TABLE OF AMENDMENTS – KDCP (consolidated) Housekeeping Amendments 2021

Ku-ring-gai Development Control Plan (Amendment 1 to KDCP 2020 (Consolidated))				
PAGE NUMBER	SECTION	EXISTING	NEW/MODIFIED	REASON FOR AMENDMENT
Introduction (Part 1)				
1-6	Intro	Part 13: Tree and Vegetation Preservation This Part of the DCP contains requirements for the preservation of trees and vegetation on all land covered by the KLEP. This Part is made in accordance with Clause 5.9 of the KLEP and prescribes the trees and vegetation to which Clause 5.9 applies. It replaces the Tree Preservation Order for the lands to which KLEP applies.	Part 13: Tree and Vegetation Preservation This Part of the DCP contains requirements for the preservation of trees and vegetation on all land covered by the KLEP. This Part is made in accordance with Part 3 of State Environmental Planning Policy (Vegetation in Non-Rural Areas) 2017 and prescribes the trees and vegetation to which Clause 9 applies. It replaces the Tree Preservation Order for the lands to which KLEP applies.	Update to reflect legislation

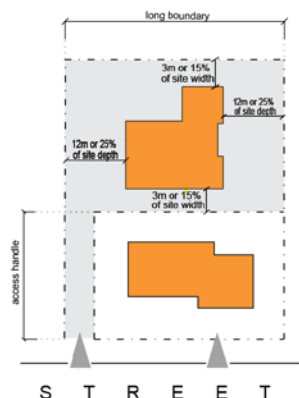
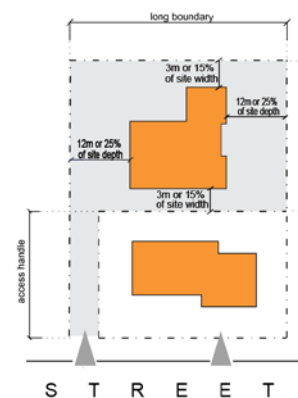
Effective Slope	Distance (m)																			
Upslope/flat to 5°	55																			
More than 5° to 10°	65																			
More than 10°	90																			
Effective Slope	Distance (m)																			
Upslope/flat to 5°	60																			
More than 5° to 10°	65																			
More than 10°	85																			
4-11	4A.2	Control 18; Figure 4A.2-8	Control 18; Figure 4A.2-8	Clarification
